# OAK RIDGE NATIONAL LABORATORY

This letter summarizes our progress on the Containment Leak Rate Testing Investigations (FIN. No. BO489) Program for the Month of May 1983.

A review of the document ANSI/ANS-56.8-1981, entitled "Containment System Leakage Testing Requirements," has been completed. This standard is an updated version of the standard ANSI N45.4-1972 entitled "Leakage Rate Testing of Containment Structures for Nuclear Reactors." As this standard was generated by the nuclear industry, it was reviewed with regard to its compatibility with the NRC requirements in Appendix J of 10CFR50. A few of the more pertinent findings follows.

Figure 1. Number of temperature sensors per test.

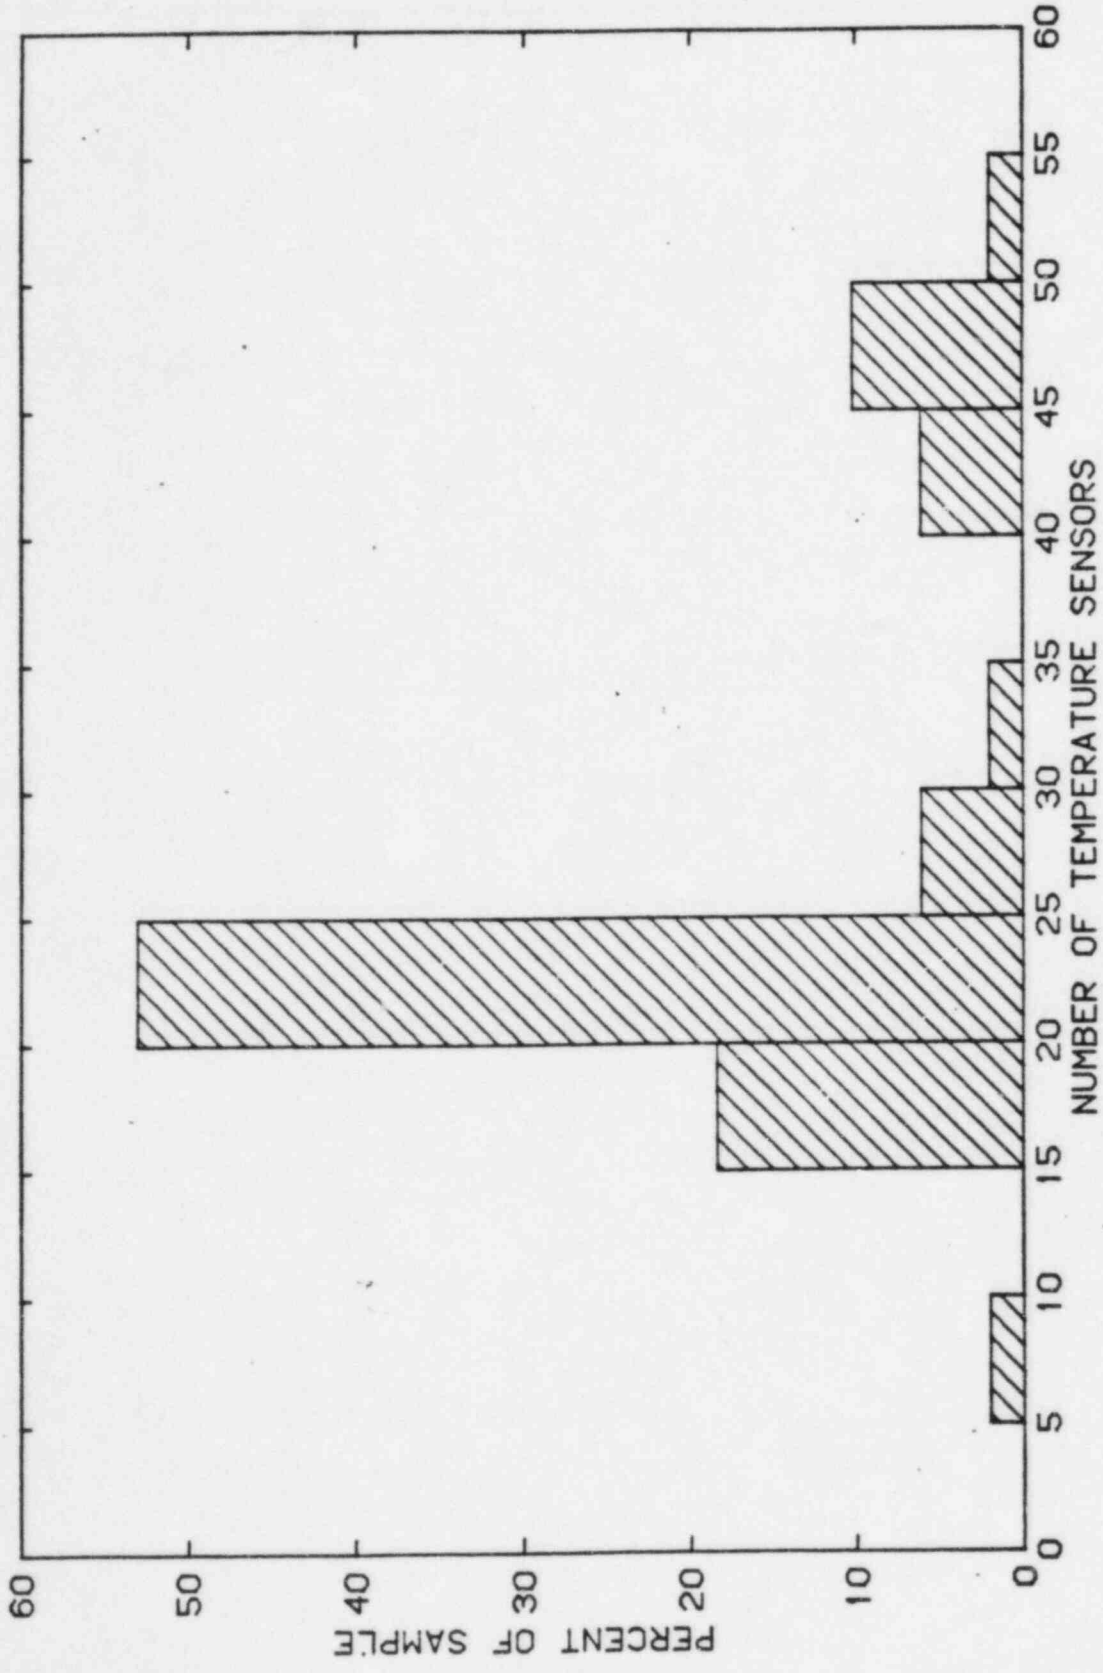
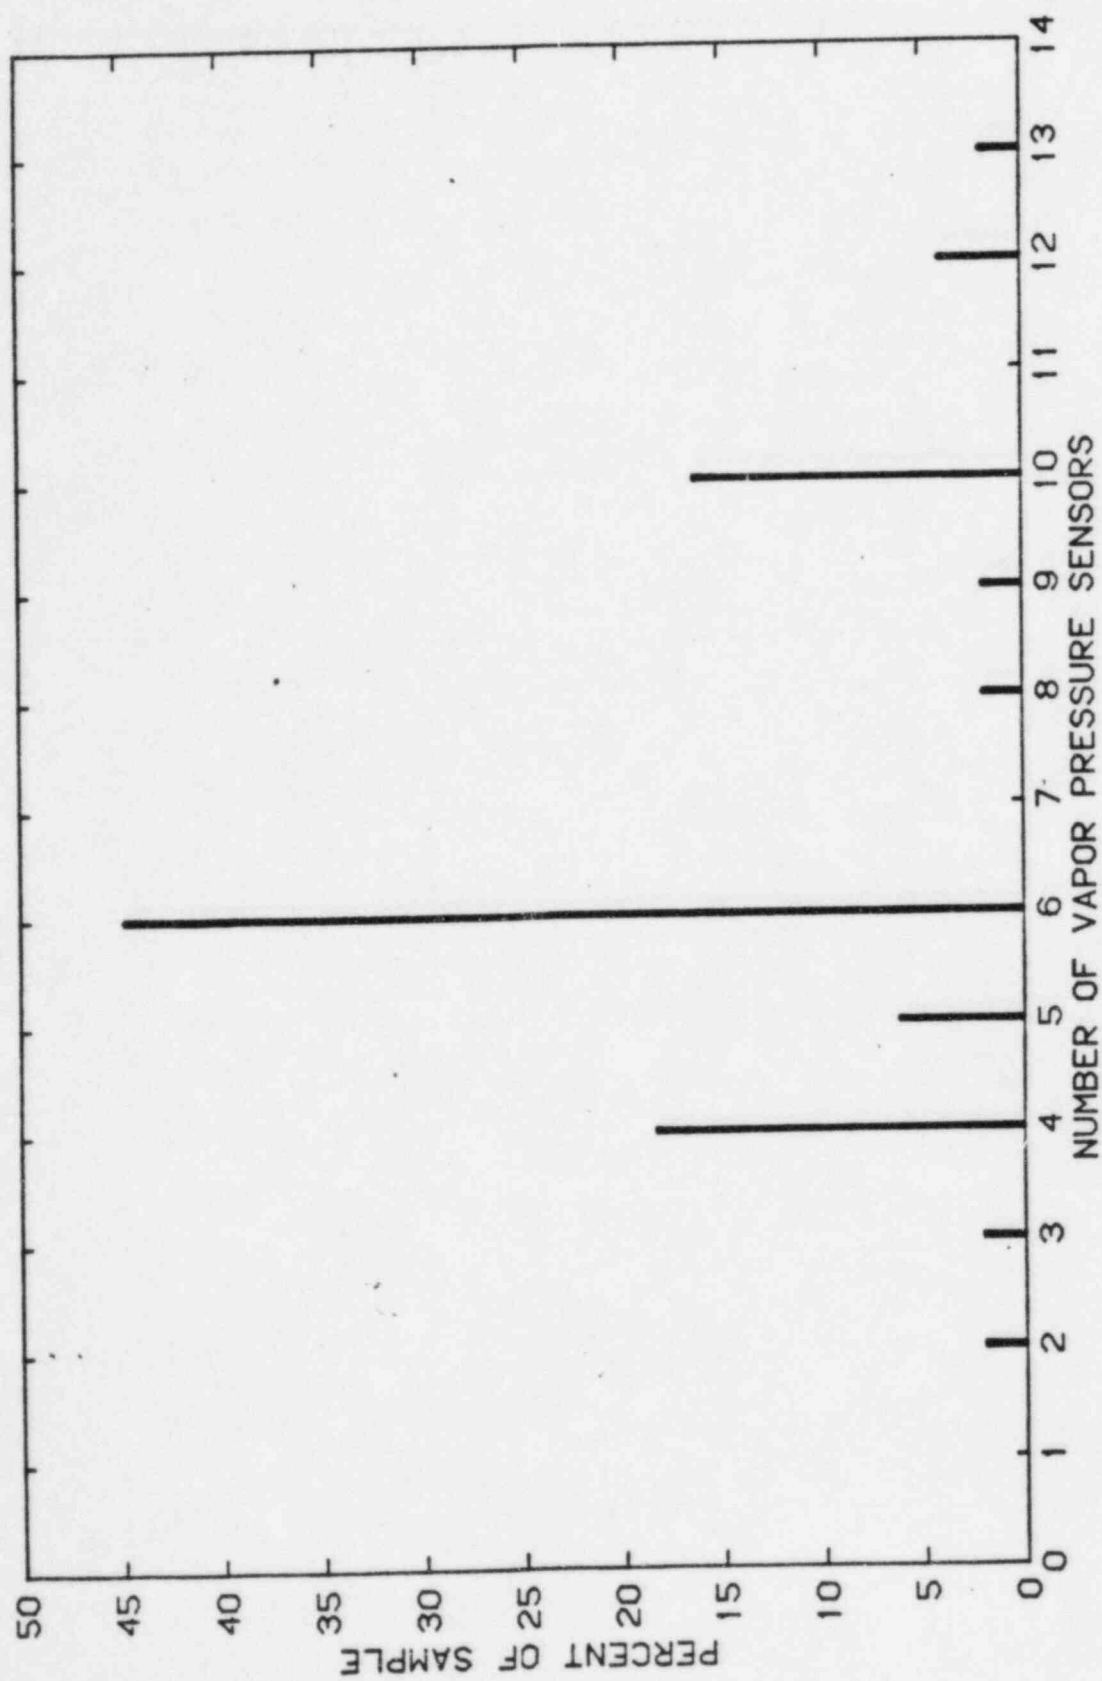
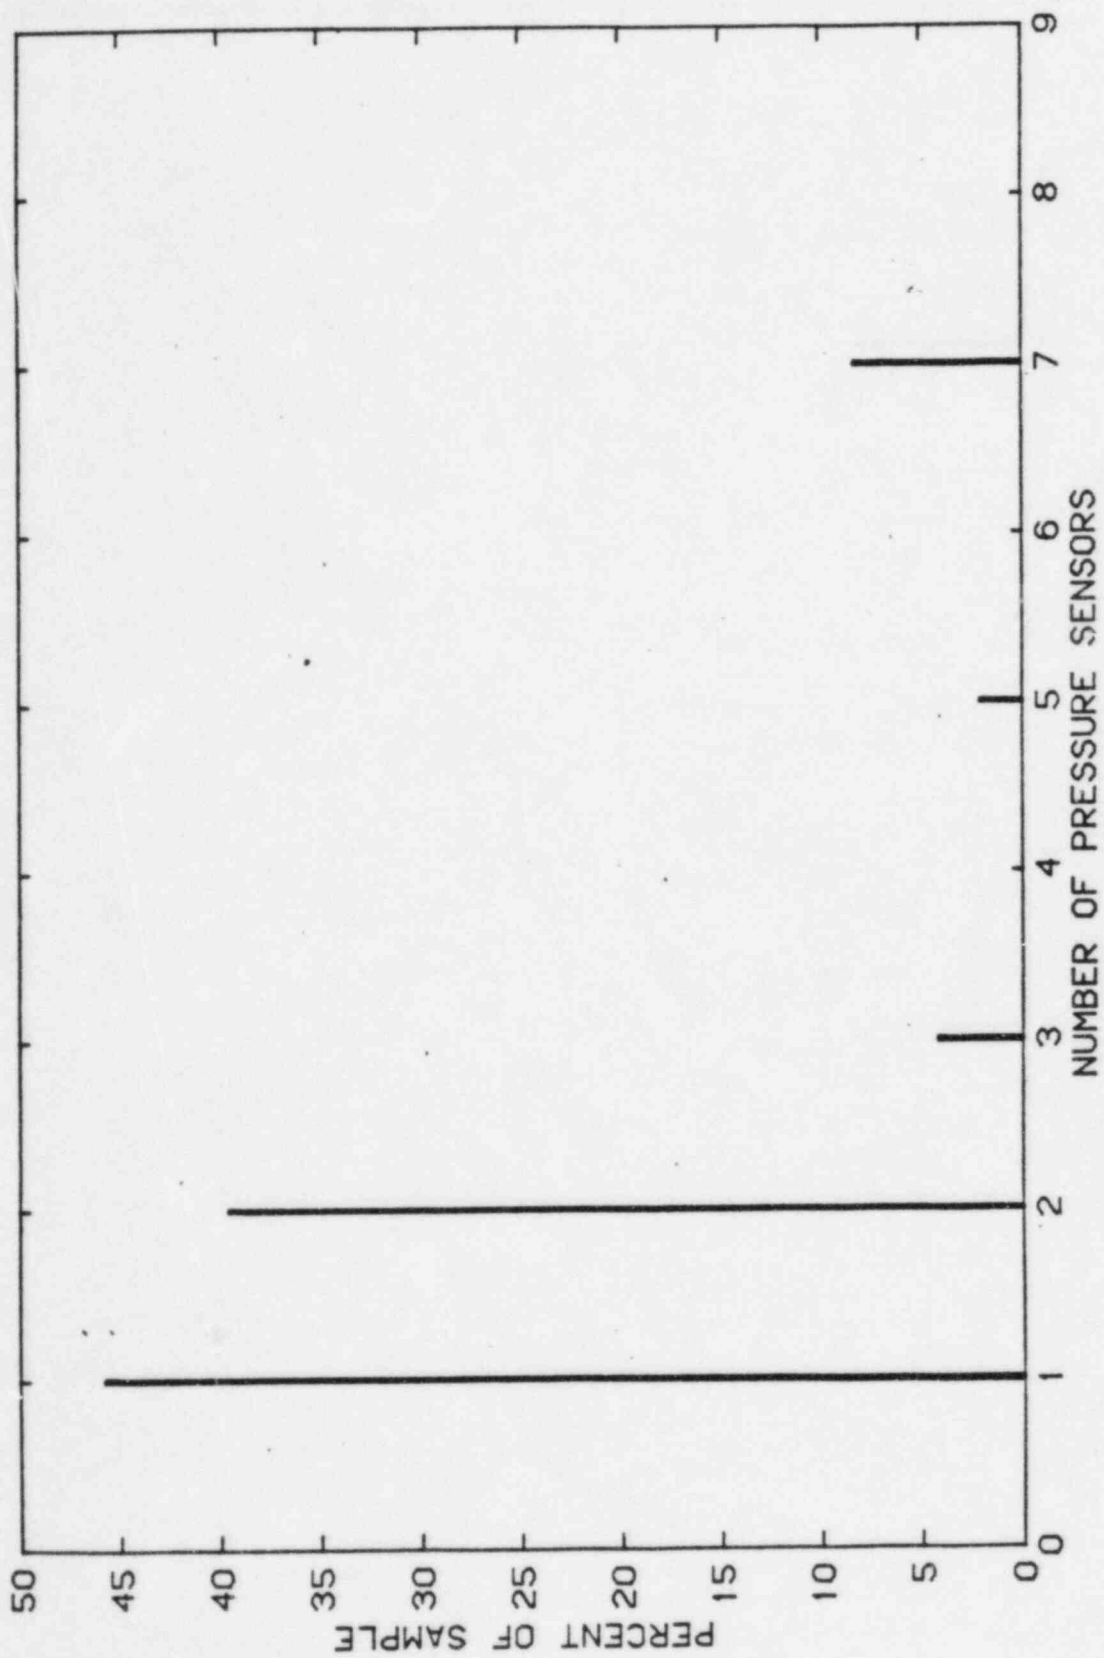
The required number of sensors is not a specified quantity in the ANSI standard, except for the minimum quantity. Sufficient temperature sensors are required such that no one sensor has greater than ten percent of the containment volume assigned to it. At least three dewpoint temperature (or vapor pressure) sensors are required, and at least one pressure sensor is required during the test. Figures 1, 2, and 3 indicate the number of temperature sensors, vapor pressure sensors, and pressure sensors, respectively, as indicated in the test reports. The bars in Figure 1 indicate a range of sensors and show that over 50 percent of the tests were conducted using 20 to 25 temperature sensors. Figure 2 indicates that most tests were conducted with 6 vapor pressure sensors and Figure 3 shows that most tests were conducted with either 1 or 2 pressure sensors only. Judging from the recorded data values, the spatial variation of temperature over an entire test was less than 5° K, and there appeared to be sufficient sensors to measure temperature and vapor pressure. However, it is difficult to state that one or even two pressure sensors is sufficient. Data were not available to allow a firm conclusion to be drawn regarding multiple pressure sensors. At least one observer has argued that multiple pressure sensors are needed. Therefore additional consideration will be given to using multiple pressure sensors.
